ADA Curb Ramp New Construction Inspection Form (Perpendicular)

Nw 294th

23885.56

Nw 292nd

PERPENDICULAR RAMP (PR)

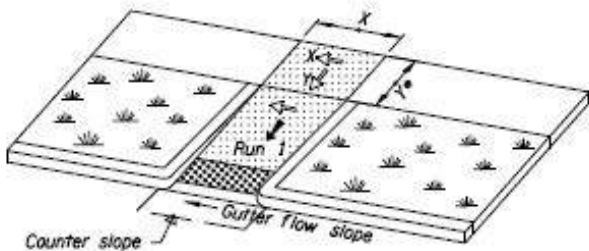
IITD RR1 fails
